**REPORT OF GEOTECHNICAL INVESTIGATION
PROPOSED HOSPITAL TOWERS**

**NORTHWEST CORNER OF BARTON ROAD AND ANDERSON STREET
LOMA LINDA UNIVERSITY MEDICAL CENTER
LOMA LINDA, CALIFORNIA**

Subject: **LETTER OF TRANSMITTAL**
 Report of Geotechnical Investigation
 Proposed Hospital Towers
 Loma Linda University Medical Center
 Northwest Corner of Barton Road and Anderson Street
 Loma Linda, California
 MACTEC Project 495310-0911

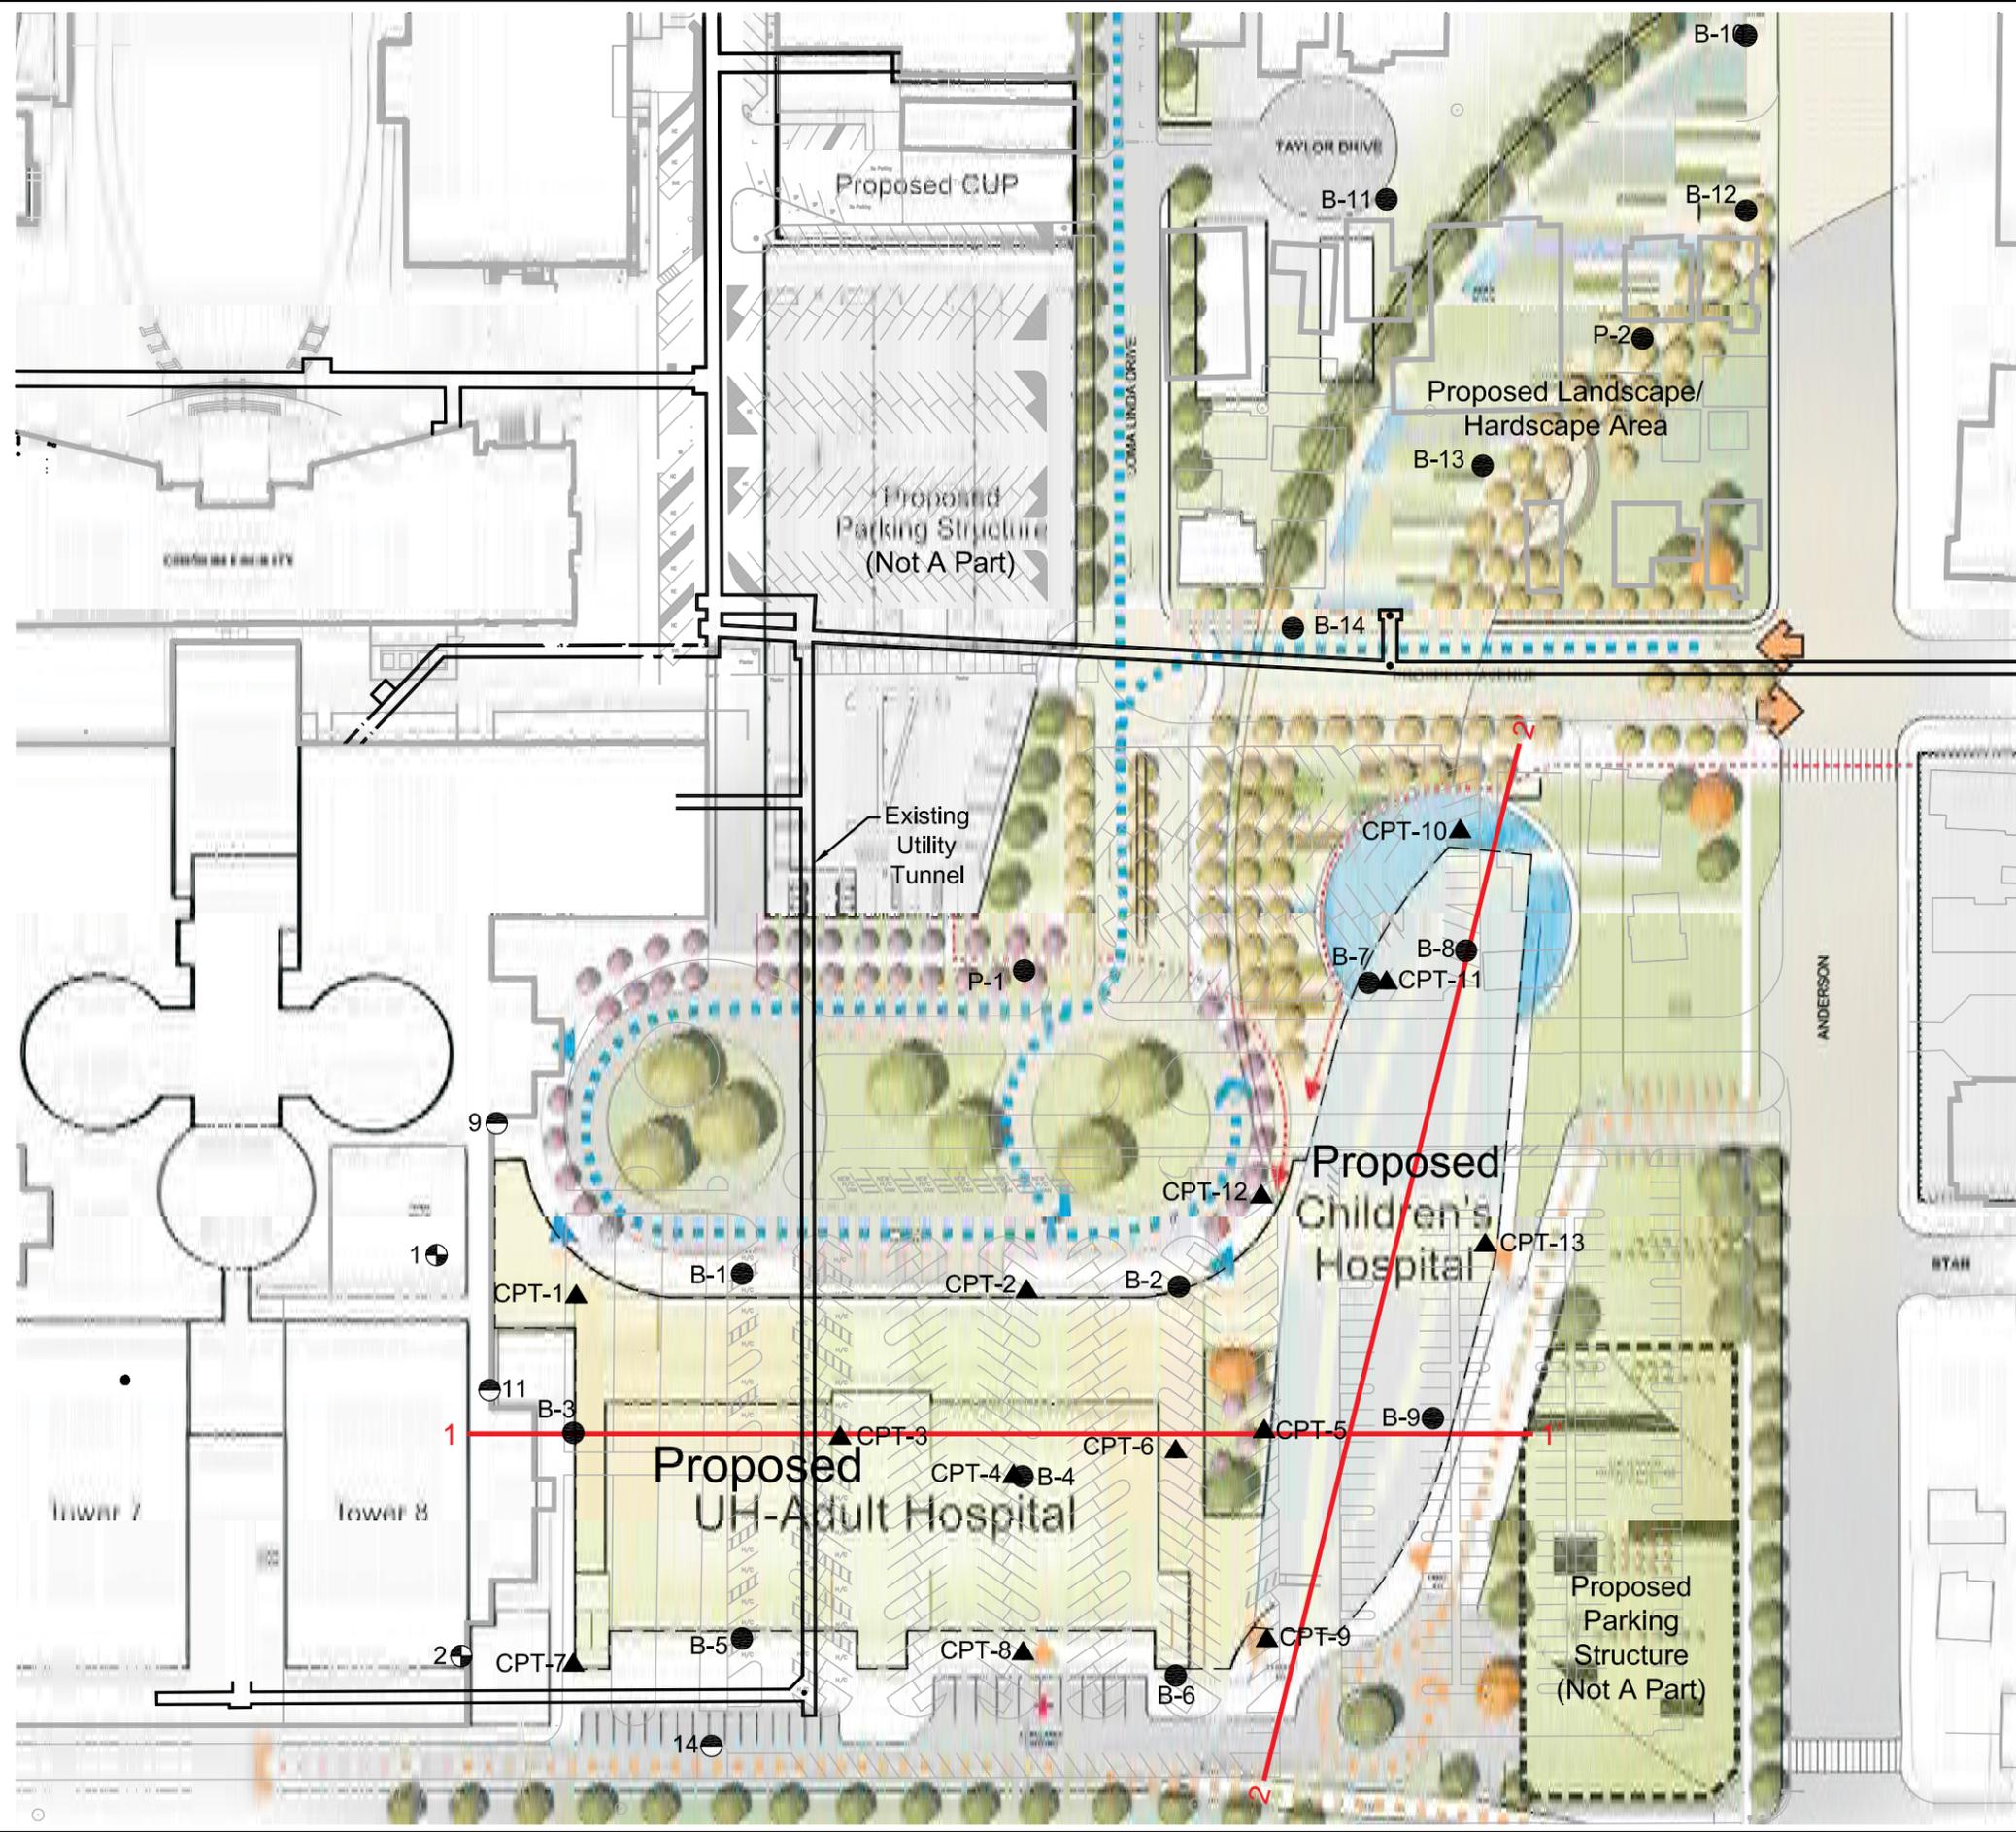
1. Site Location: Adequately addressed.
2. Plot Plan with Exploration Data and Building Footprint: Adequately addressed. The consultants provide a Plot Plan (Figure 2) indicating the location of the two proposed hospital buildings and the location of 9 borings and 13 cone penetration tests (CPT). Additionally, the consultants supplement their current subsurface investigation data with 5 borings drilled during previous investigations at the site.
3. Site Coordinates: Adequately addressed. The consultant provides site coordinates: 34.0490°N and -117.2628°W.

Two cross sections have been prepared and are attached to this letter. The locations of the cross sections are shown on Figure 1, Plot Plan. The cross sections depicting the limits of proposed and nearby existing basements, the existing utility tunnel, and the subsurface conditions encountered are shown on Figures 2.1 and 2.2, Cross Section 1-1' and 2-2', respectively.
